Form 3160-5 (June 2019)

Update casing and cement program to current design.

Revised Permit Information 11/08/2023:

Well Name: Audacious 19 Fed Com 581H

1692' Revised Wellbore B: KB: 3476' 2367' GL: 3451'

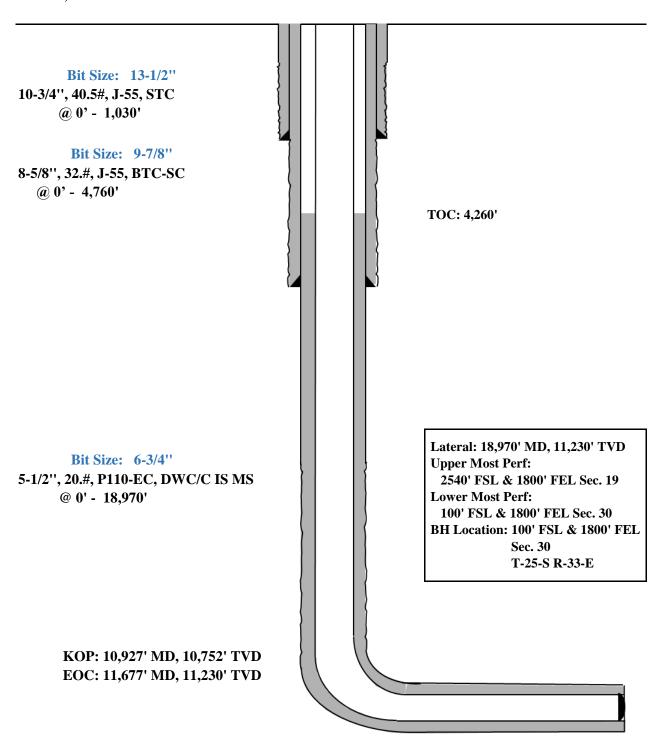
1. CASING PROGRAM B:

Variance is requested to waive the centralizer requirements for the 8-5/8" casing in the 9-7/8" hole size. An expansion additive will be utilized, in the cement slurry, for the entire length of the 9-7/8" hole interval to maximize cement bond and zonal isolation.

Variance is also requested to waive any centralizer requirements for the 5-1/2" casing in the 6-3/4" hole size. An expansion additive will be utilized, in the cement slurry, for the entire length of the 6-3/4" hole interval to maximize cement bond and zonal isolation.

EOG requests permission to allow deviation from the 0.422" annulus clearance requirement for the intermediate (salt) section from Onshore Order #2 under the following conditions:

1692' FSL Revised Wellbore A: KB: 3476' 2367' FWL GL: 3451'

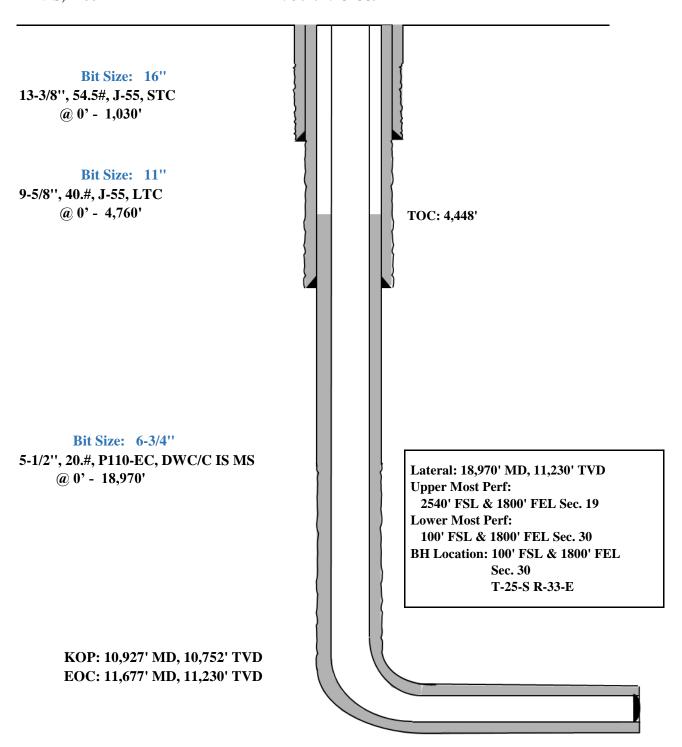
Revised Permit Information 11/08/2023:
